Basement Impact
Assessment Audit

4 The Grove, London N6 6JU

For
London Borough of Camden

Project No.
14006-27

Response from Tier Consult on the as
built layout of the neighbouring
basement

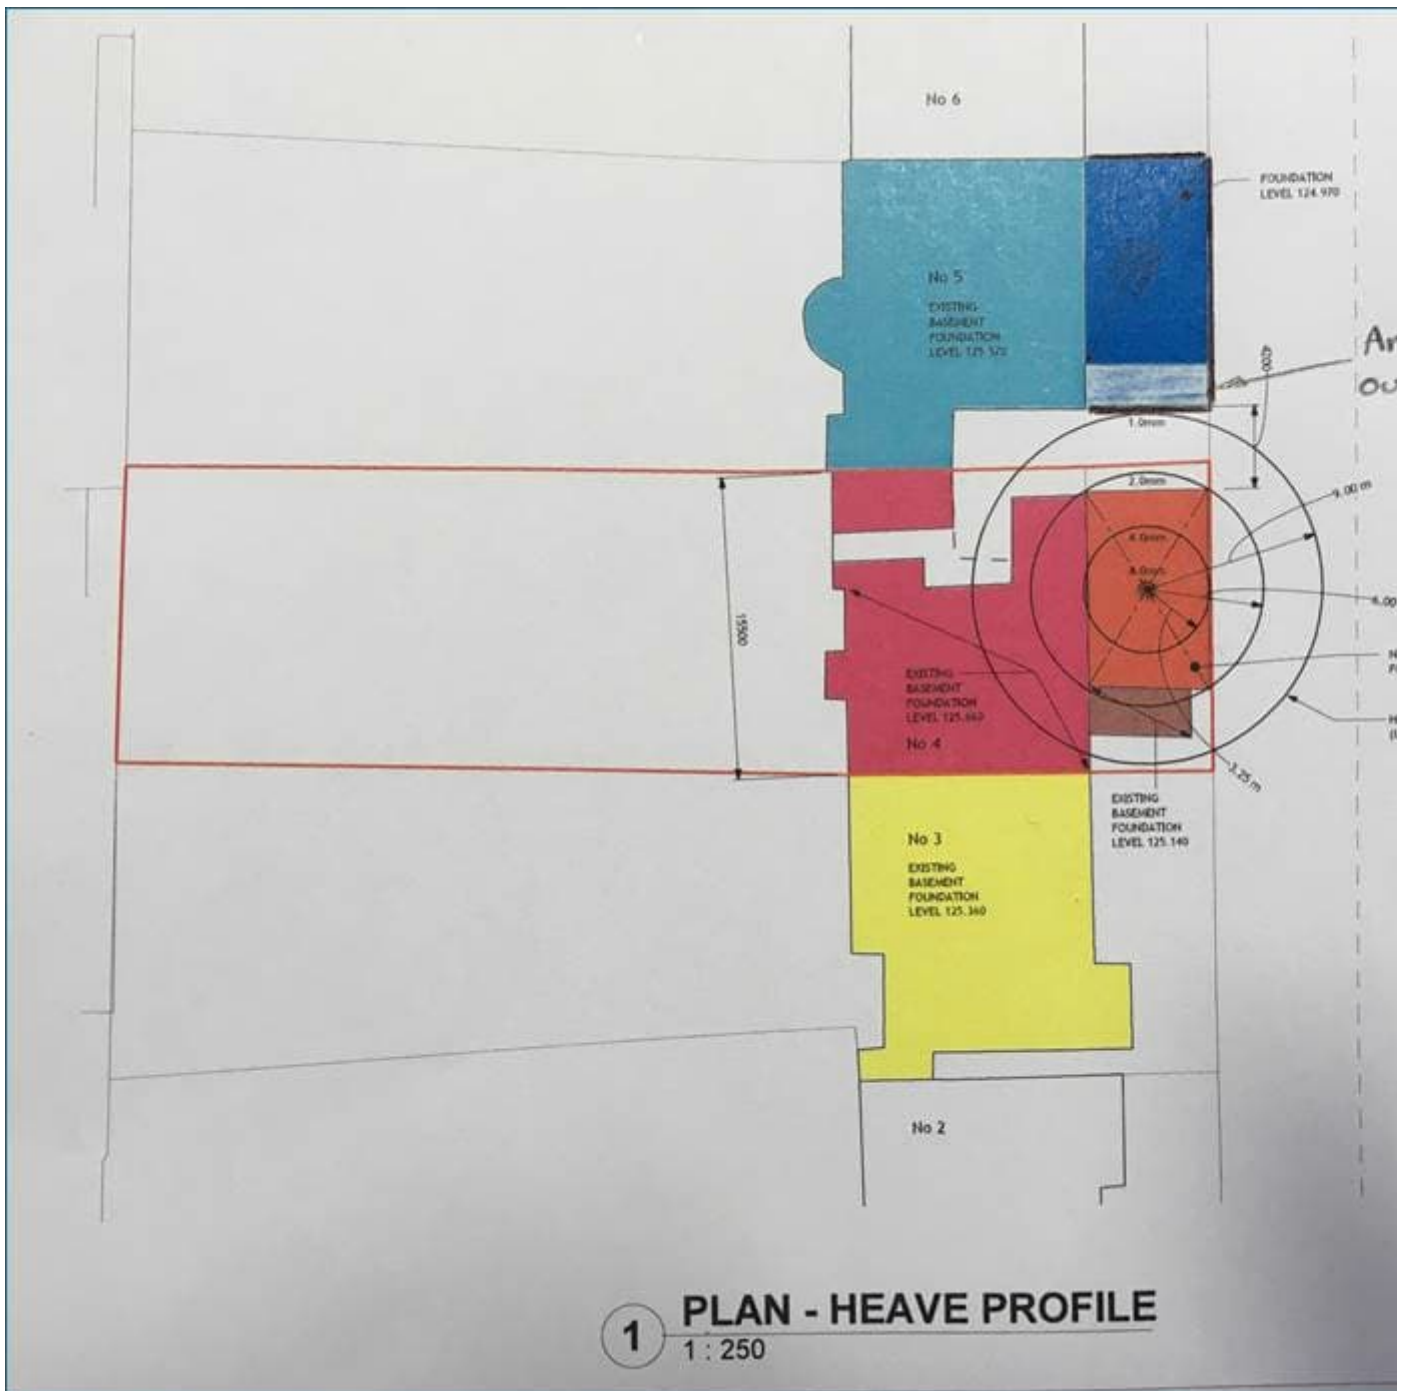
Thank for your email. You are correct, we appear to have transcribed, onto our Heave Drawing, the new basement at N^o. 5, The Grove as somewhat smaller than it actually is. We shall comment below on what implications this may have in respect of the heave profile shown on our drawing, but prior to that, I wanted to confirm, what is implied in your email, that this basement is unaffected by ground movements associated with sheet pile installation and excavation. These all happen above the depth at which this basement is founded.

You have also asked us to comment on the "impact on the hydrology, subterranean flow, and land stability". In our BIA we note that "*the effect of the proposed basement on the hydrology, hydrogeology and land stability have been considered and found to be negligible*". We similarly note that the ground water is in excess of 7.5m below the level of the N^o. 4 basement and so this proposed basement cannot have an impact on subterranean flow(s). We can further confirm that the changed relationship between the basement at 5, The Grove and the proposed basement at 4, The Grove (illustrated below) will not change these conclusions.

In respect of heave, the sketch below shows that the amended basement outline brings it onto the theoretical 1mm heave contour. That in itself would have a negligible effect on the No. 5 basement. However, this basement has been formed within a contiguous pile wall and this will have the effect of anchoring this basement into deeper ground on which there is even less impact. With this additional anchoring, we believe that movement of the N^o. 5 basement, as a result of the formation of a new basement at 4, The Grove will be almost unmeasurable.

Drawing No : **073-TCE-XX-LG-D-S-250** **P1**

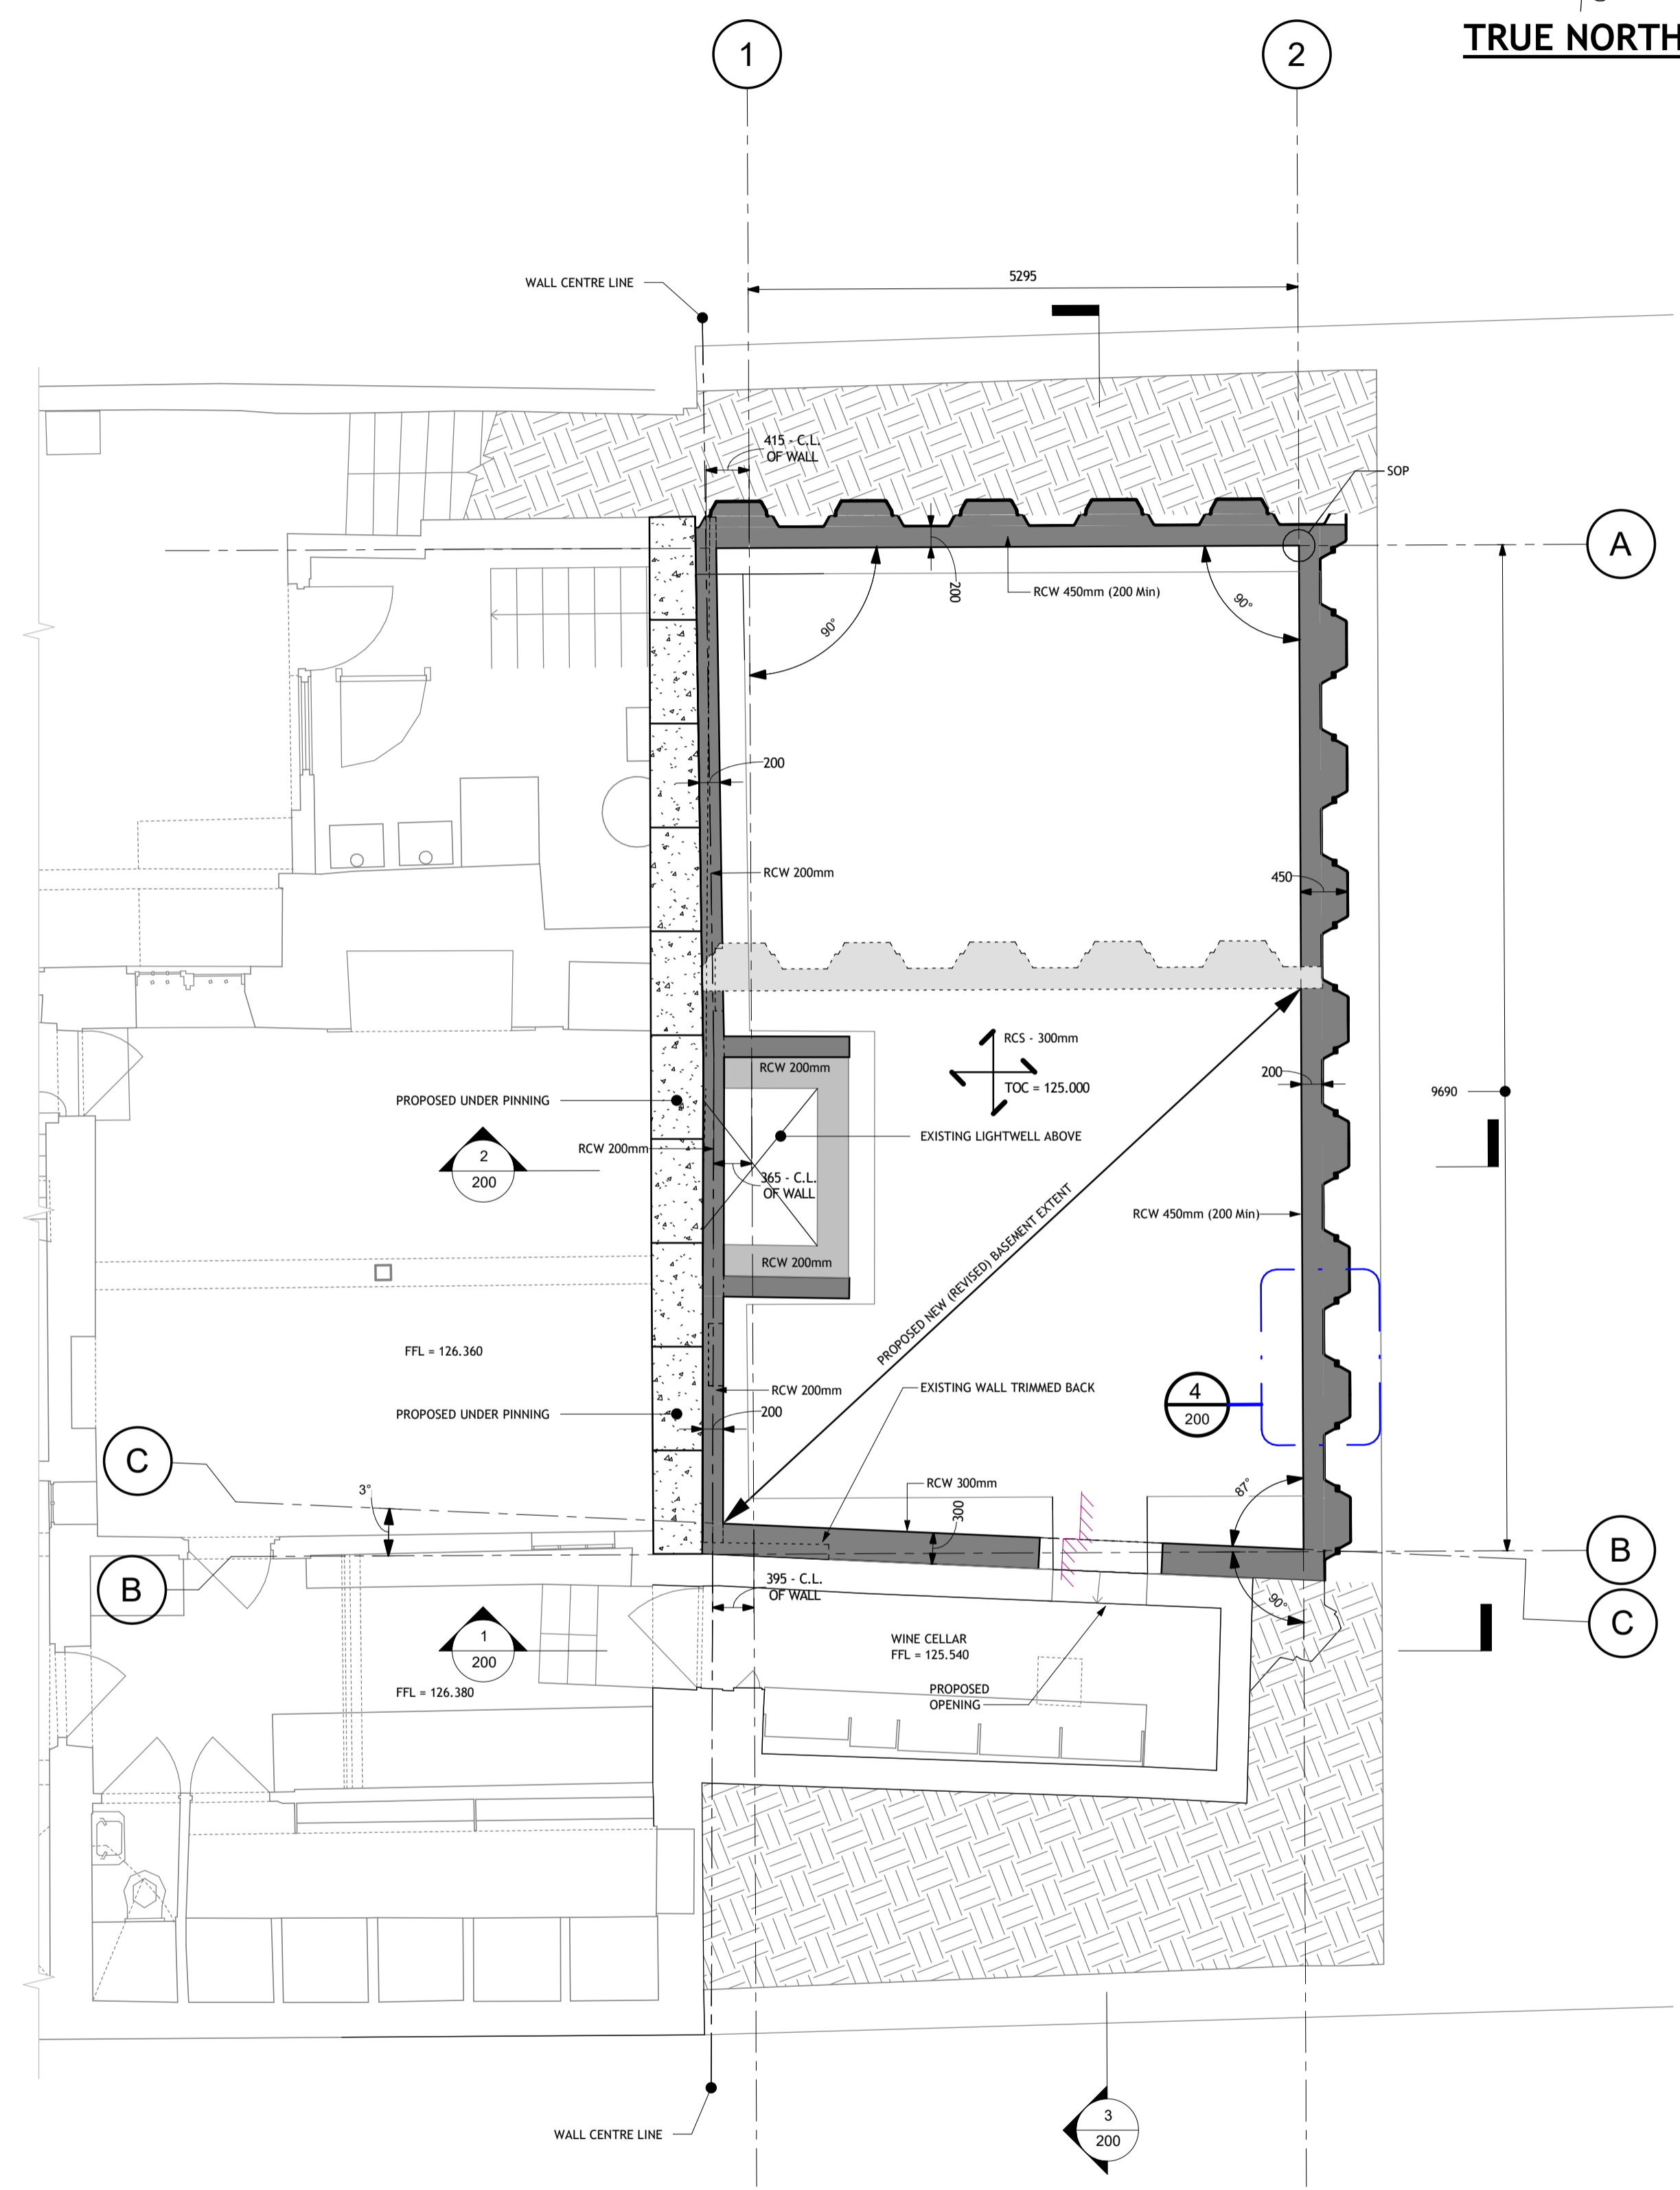
Following discussions with the London Borough of Camden, a revised basement extent has been proposed. This is illustrated on Tier drawing 073-TCE-XX-LG-D-S-250 (P1). From this drawing it can be seen that the new basement extent is approximately half that previously proposed. The effect of that reduction on the Key Drivers included in the BIA are discussed below.

The Newmark method used as part of the heave assessment illustrates quite well the vertical stress Influence Factor is a function of the length and breadth of the excavation. With the original excavation, the likely heave was acceptable, with significantly reduced area of dig the heave also will be significantly reduced.

Whilst largely a function of excavation depth, which is unchanged, the new basement area is now almost square and so “corner effects” will be even more significant. The zone of influence now covers a reduced ground area. The combination of these two factors will reduce the quantum of movement (both vertical and horizontal) and the area over which these occur.

The new proposals require a reduced length of underpinning. This is likely to lead to a somewhat stiffer response from the superstructure and so a marginal reduction of movement may be expected. However, largely the local effects of the underpinning are unchanged by the revised proposals.
